Appeal of PTF2019-0004 – Murray/Walker Road Improvements

Appeal filing document – July 22, 2020

Appeal APP2020-0005 – Marc San Soucie

PTF2019-0004 - The Issue

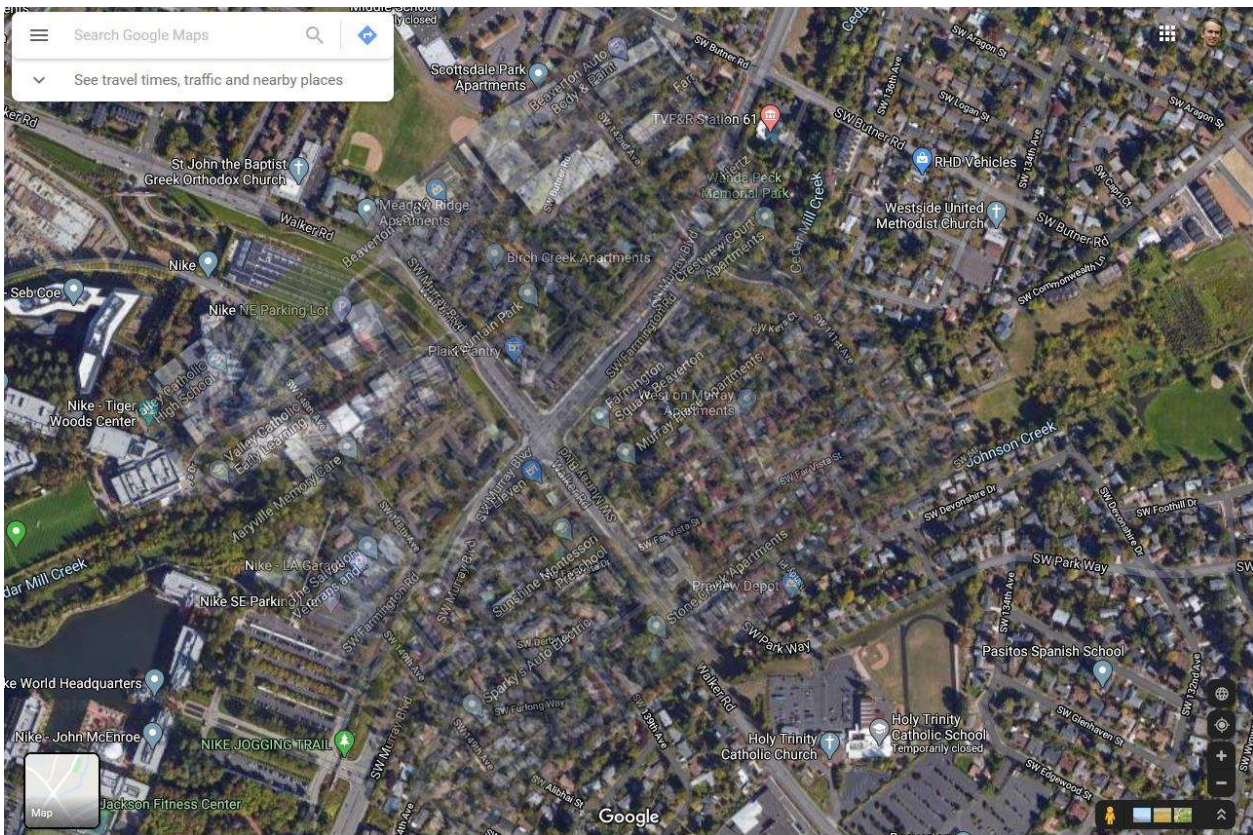
Solutions Report Appendix H: “Walker Road/Murray Boulevard Intersection Improvements: A number of improvements at Walker Road/Murray Boulevard are included in the 2015 TSP for this intersection of two arterials. Right turn demand is generally high and supports the addition of right turn lanes on each approach. Dual left turn lanes are already provided on the eastbound Walker Road approach, and the westbound approach already has an empty median that shadows the opposing left turn movement. Northbound and southbound left turn movements on Murray Boulevard are projected to be 200 vehicles or less during the 2035 PM peak hour, indicating that the volume levels are not sufficient to support the widening required to align the Murray Boulevard approaches after the addition of turn lanes.”

Note that there is no mention of slip lanes (channelization) for this intersection.
